PETITION NO: Z-19

PROPOSED USE: Service/Retail
Businesses

Z-19

FLAT OF SURVEY FOR ANGELYN CLAY WALKER

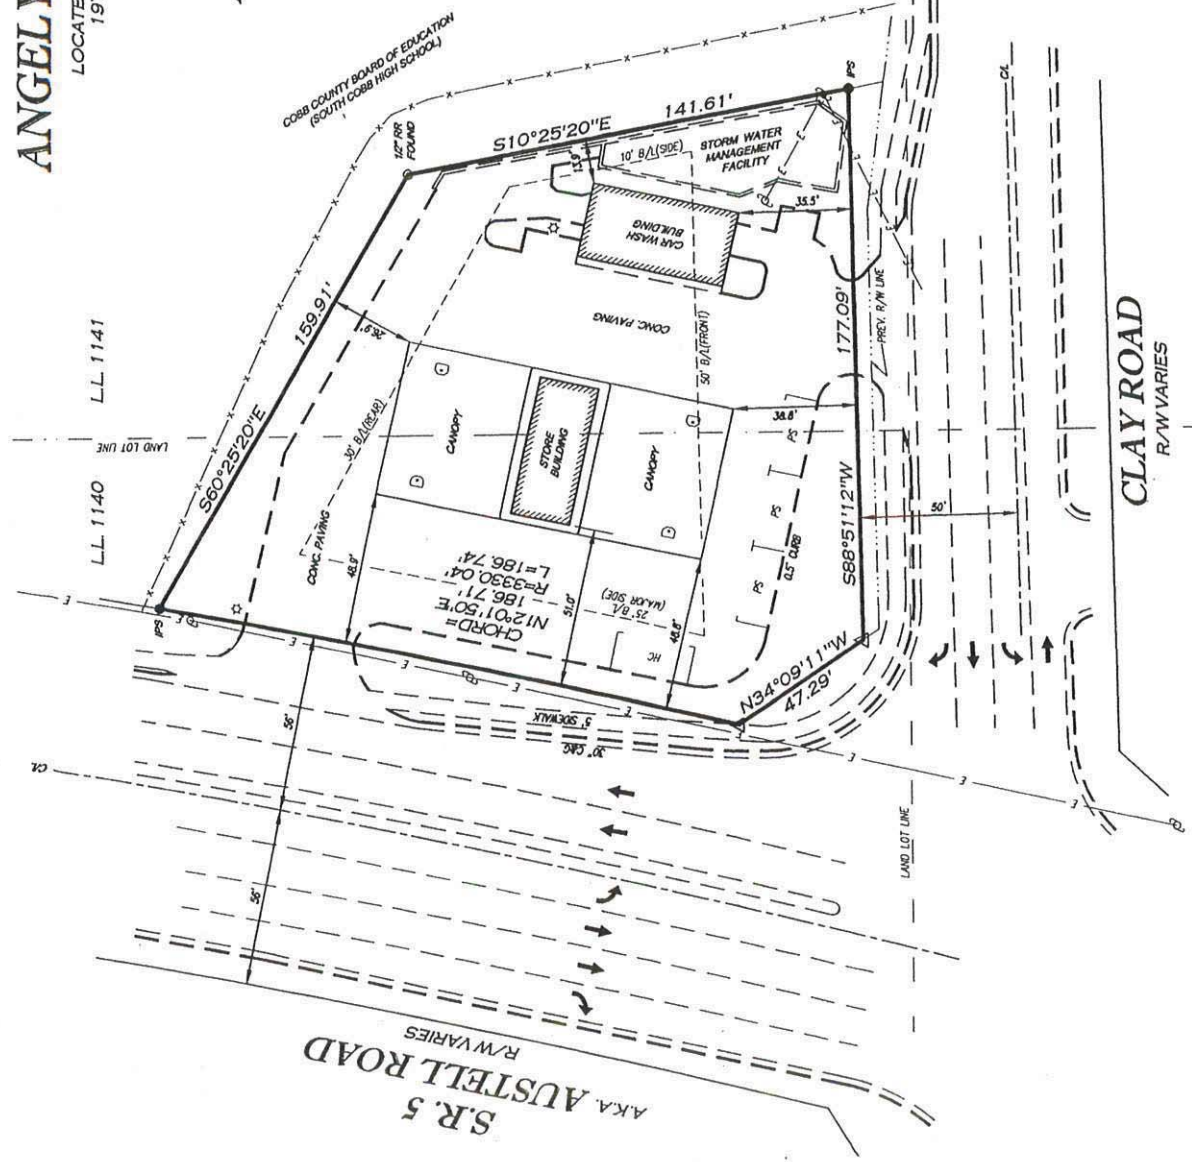
- No Stormwater controls shown _____
- Copy of survey is not current - Additional comments may be forthcoming when current site conditions are exposed.
- No site improvements showing on exhibit.
